SUBJECT: INSTALLATION OF STOP BRACKET ON EMERGENCY EXIT DOOR OPERATING MECHANISM (MOD N495)

Manufacture and Installation of Stop Bracket (Mod N495)
Figure 1

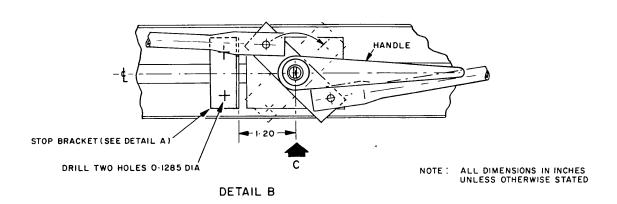
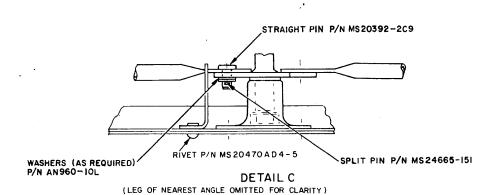
A bracket is manufactured and riveted to the inside of the emergency exit door outer wall. The bracket limits the range of movement of the latch mechanism forward push-rod so that the linkage cannot be forced over-centre. The bracket also serves to prevent cross-connection of the forward and aft pushrods at the latch operating lever during maintenance or repair operations.

- A. Manufacture stop bracket P/N NMD-52-4-1 (Ref Figure 1, Detail A).
- B. Remove the emergency exit door from the aircraft (Ref MM 52-20-00).
- C. Remove the emergency exit door window panel assembly (Ref IPC 52-20-01 Figure 1 Item 4).
- D. Place stop bracket P/N NMD-52-4-1 in position (Ref Figure 1), mark its position, then use one of the holes in the stop bracket as a drill guide to drill a 0.1285 inch diameter hole in the door outer wall.

- F. Hold the stop bracket in the marked position against the inside surface of the emergency exit door outer wall and align the previously-drilled hole in the door panel with the corresponding hole in the stop bracket. Using the other hole in the stop bracket as a drill guide, drill a second 0.1285 inch diameter hole in the door outer wall.

- G. Rivet the stop bracket to the emergency exit door outer wall using two rivets P/N MS20470AD4-5 or equivalent.
- H. Re-assemble the latch mechanism forward push rod to the operating lever using the original straight pin and washer (Ref Para 2.E) add additional washers P/N AN960-10L as required to eliminate end float in the straight pin then secure with a new split pin P/N MS24665-151.
